UNITED STATES
DEPARTMENT OF THE INTERIOR
BUREAU OF LAND MANAGEMENTOCD Artesia
05/15/2012FORM APPROVED
OMB NO. 1004-0135
Expires: July 31, 2010**SUNDRY NOTICES AND REPORTS ON WELLS**
Do not use this form for proposals to drill or to re-enter an abandoned well. Use form 3160-3 (APD) for such proposals.5 Lease Serial No
NMLC028992H

☐ Oil Well ☐ Gas Well ☒ Other. INJECTION8. Well Name and No.
LOCO HILLS SWD 34 52 Name of Operator
COG OPERATING LLCContact. CHASITY JACKSON
E-Mail. cjackson@concho.com9. API Well No
30-015-39477-00-X13a Address
550 WEST TEXAS AVENUE SUITE 100
MIDLAND, TX 797013b Phone No (include area code)
Ph: 432-686-308710 Field and Pool, or Exploratory
SALT WATER DISPOSAL (SWD)

Notice of Intent for completion of Loco Hills SWD 34 #5. SWD-1284
Please see attachment. Logs are mailed.

- II. **Objective of Notice:** Provision of a second set of supplemental information for this completion NOI.
- III. **Reason for Notice:** To answer additional questions set forth by the BLM on April 5, 2012 on this well. Also to provide supplemental information and/or acknowledge receipt of and intent to comply with those instructions issued in that notice.

Well: Loco Hills SWD 34 #5

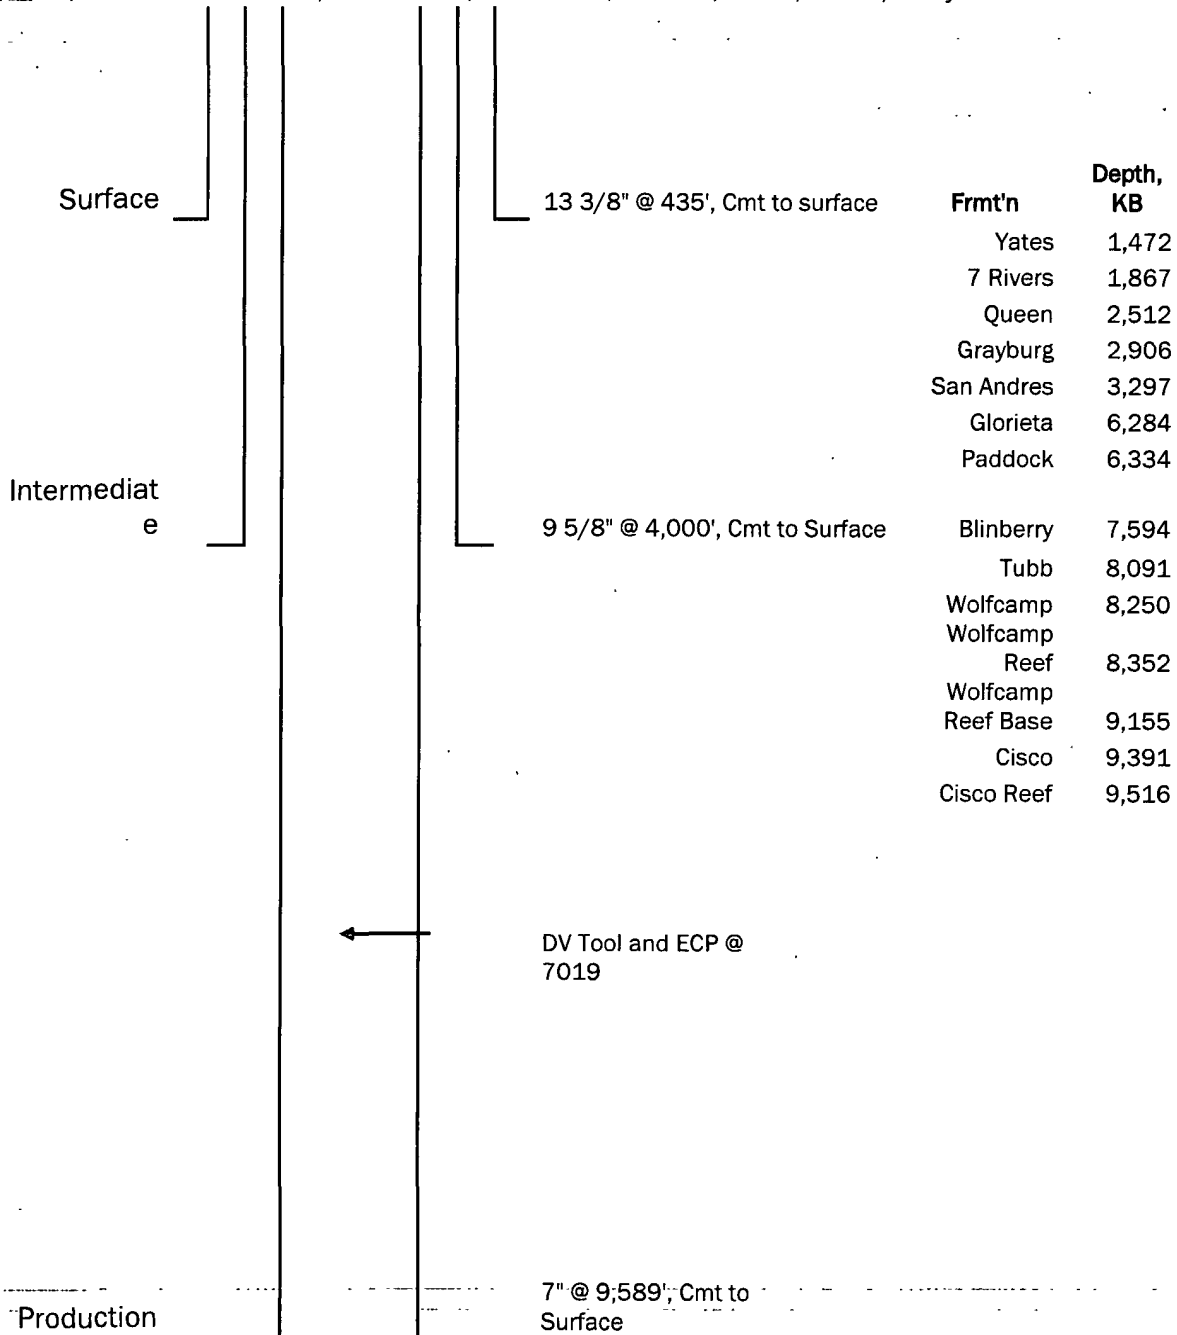
- IV. **Answers:**
Question as stated by BLM on April 5, 2012.
 1. Operator stated that they drilled the well according to the approved 3160-3. The BLM stated in the Conditions of Approval that the surface casing was to be set at approximately 360'. Operator to explain why casing was set at 435' since there is no information requesting a change in depth.

- a. Operator stated that they received approval from Richard Carrasco at 1444 hours 1/19/2012. If operator was drilling at 40 fph they were already past the approved depth at this time. Approximate depth at time of request calculates to 385'.

- b. Richard Carrasco does not have authority to change the casing depths. That has to be approved by a BLM engineer and there is no confirmation in the BLM files that support this request even to Richard. Once the logs are received, they will be used to verify that COG set in the Rustler.

- 1a. The top of the Rustler as picked by our Mud Logger (Log Attached) is 372 and the additional 25' would be 397'. To match the casing on location we requested and were granted a depth of 435', an additional 38'.
- 1b. COG was not informed of an authority issue in the depth request. We maintain call logs of our activities.
